## Technical Bulletin 156 - GTK15 Recirculation Pump with SENSEI™ Tankless Water Heaters

**Purpose:** The GTK15 recirculation pump timer is not compatible with SENSEI™ Tankless Water Heaters.

Figure 1

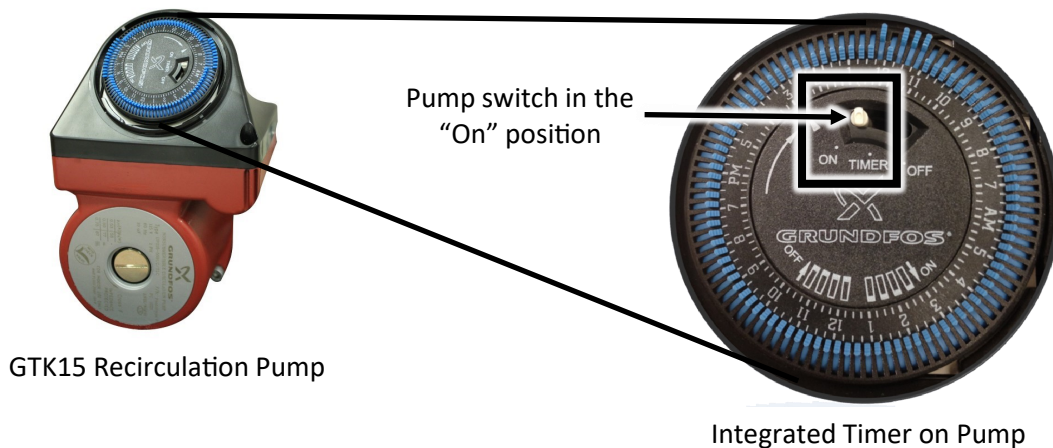
When a GTK15 recirculation pump is used with a SENSEI™ Tankless Water Heater, the integrated timer on the pump is not compatible with the tankless water heater. SENSEI™ Tankless Water Heaters include a diagnostic feature that monitors the recirculation flow rate. If recirculation flow is low or not detected, the tankless water heater will display diagnostic code 63. While code 63 is displayed, hot water will remain available from the tankless water heater but the recirculation pump will be disabled until the source of the diagnostic code is identified and resolved.

If you currently have a GTK15 pump with a non-RUR SENSEI™ Tankless Water Heater and are experiencing a code 63, follow the steps below:

- Turn the pump switch to the “On” position (Figure 1). Recirculation will begin running 24/7 based on the tankless water heater’s parameter settings for Comfort or Economy Mode.
- An MC-195T controller or Control-R™ Wi-Fi Module (Figure 2) must be used to set the recirculation schedule for the tankless water heater.
- Follow the installation and operation instructions included with the MC-195T controller or Control-R™ Wi-Fi Module to set the recirculation schedule for the tankless water heater.
